CONCEPT DISCUSSION

CONCEPT B - EXPANDED STREETScape

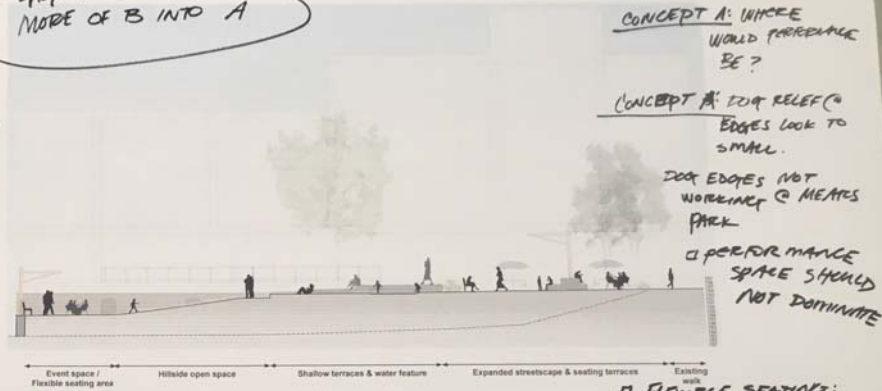
TRY TO BRING MORE OF B INTO A

- HOUSE / CROWDED FEELING FOR (B)
- OPEN SPACE IS BETTER BUT NOTHING UNIQUE
- MAY BE MORE / LESS TRESS TO OPEN IT UP

TO MANY TREES / CROWDED

CONCEPT A: WHOSE WORLD PERCEPTION BE?
 CONCEPT A: EDGE RELIEF @ EDGES LOOK TO SMALL.
 DOOR EDGES NOT WORKING @ MEETS PARK
 □ PERFORMANCE SPACE SHOULD NOT DOMINATE

□ NOT ANOTHER MORGAN PARK - FOR LARGE EVENTS
 □ NEEDS MORE FOR YOUNG FAMILIES & GRANDPARENTS

□ FLEXIBLE SEATING: WHAT DO WE THINK OF THIS?
 POSITIVE
 □ BUDGET COLOR POP IS IMPORTANT!
 □ GIANT TREE IDEA

DOWN TO SAME STRUCTURES: TERRACES
 FEELS UNDERUTILIZED

□ LIGHTING: NOT SEEING THAT - ACCENT LIGHTS, LIGHTS FROM ADJACENT BLDGS, ILLUMINATION OF STREET TREES

- YEAR ROUND PARK NOT SEEING THIS IN DESIGNS
- AREA FOR KIDS TO SLIDE IN CITY
- CONCEPT A: PLAY
- NO SWIMMING SHOWN - THAT HAVE THIS

□ OPEN SPACE: MAYBE TOO MUCH OPEN SPACE EDGES WOULD BE CROWDED. " IF ONLY WE HAD DOMINATE THE SPACE "
 COULD WE INTRODUCE SOMETHING TO BRING THEM IN

□ WHAT DID WE MISS? WINTER APPAL / FIRE PIT IDEA WOULD BE HEAPPAL
